This Service Information bulletin supersedes SI B13 07 12 **dated May 2014.**

MODEL

F01 and F02 (7 Series Sedan)	F04 (ActiveHybrid 7)	F07 (Gran Turismo)	F10 (5 Series Sedan)
F12 (6 Series Convertible)	F13 (6 Series Coupe)	E70 (X5)	E71 (X6)

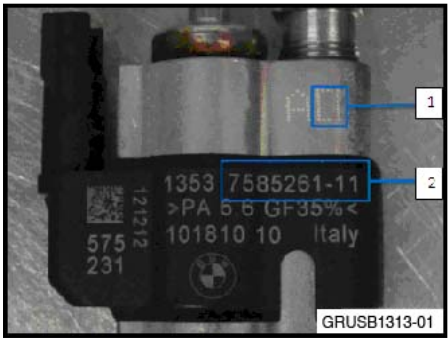
As of January 2013, an improved injector is available. Two distinct markings on the injector itself will identify the improved injector.

1 = Internal material improvement

2 = 7585261 – (index) 11 or greater

The injector improvements consist of an internal filter and optimized thermal compensating oil.

IMPORTANT: Injectors with index 11 and higher have a different calibration and construction than injectors with index 10 and lower.

UPDATE! Due to this difference, the injectors with index 11 and higher and injectors with index 10 and lower cannot be mixed on the same engine bank (e.g., cylinders 1-4 or 5-8). For index 11 injector failures, only replace the failed injector.

Use **P/N 13 53 8 616 079** when replacing the injector(s).
